Addendum 4

Columbus County 911 Center

Project Name
 COLUMBUS 911 CALL CENTER
 RTU UPFIT
 WHITEVILLE, NORTH CAROLINA
 Sheet Title
 FRAME SCREEN SECTION (PARALLEL TO JOISTS)

5 FRAME SCREEN SECTION (PARALLEL TO JOISTS)
 ARCH REF: 6/A-5.2

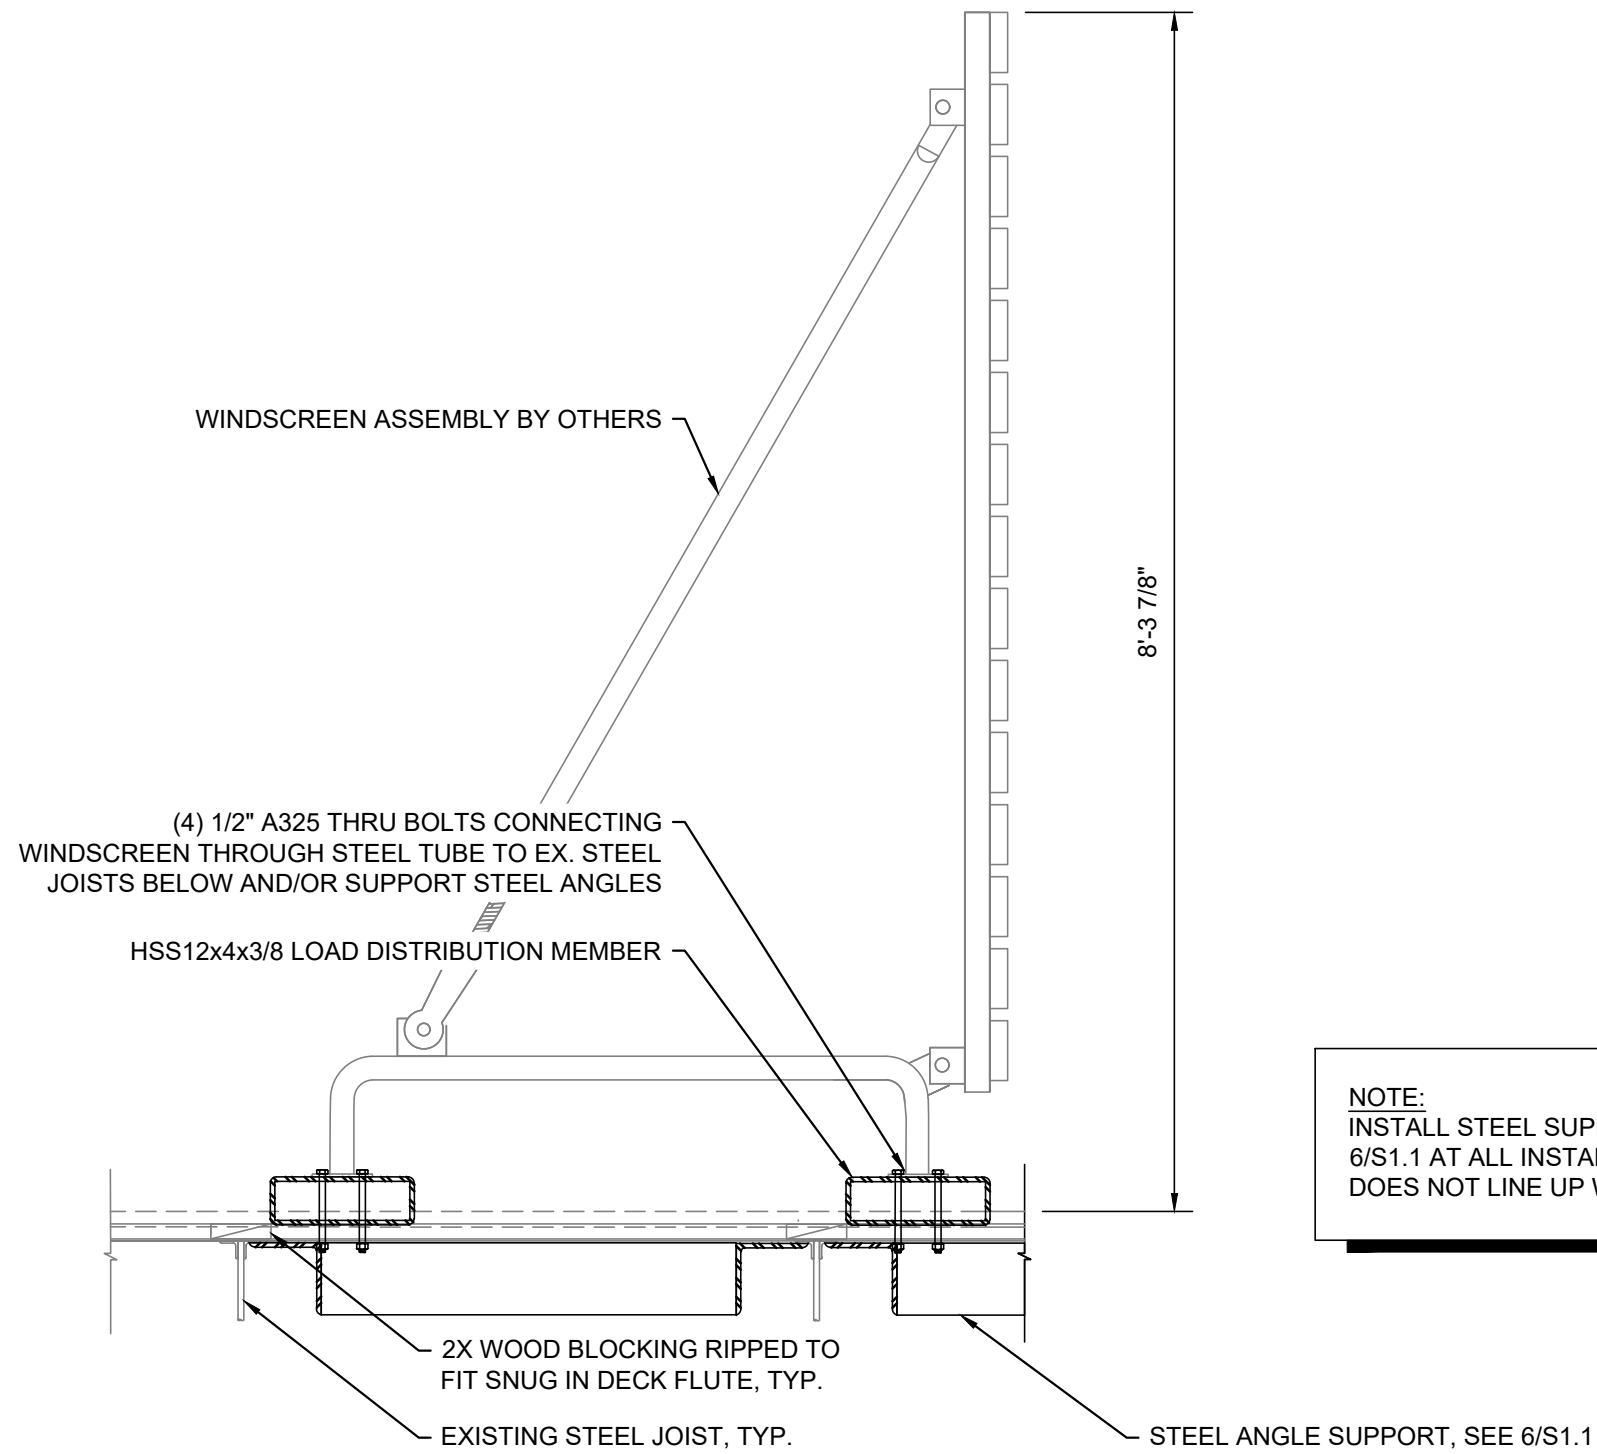
- Clarification: 2, 3 and 4/A-1.2; Details are for generic shear walls, they can be modified to annotate 3.58" walls vs 6 as the case may be. The shear walls are simple braced elements within the otherwise standard interior LGS partition wall. Only the chords, (the extreme ends), and the strapping is the part of the shear wall. The standard top and bottom track is that of a typical interior partition wall.
- Clarification: See Attached SK01 for clarification on Frame Screen Parallel to Joists.
- Clarification: Cat 6a cabling is to be part of the base bid.

NOTE:
 INSTALL STEEL SUPPORT ANGLES DETAILED IN 6/S1.1 AT ALL INSTANCES WHERE FRAME SCREEN DOES NOT LINE UP WITH EXISTING JOISTS
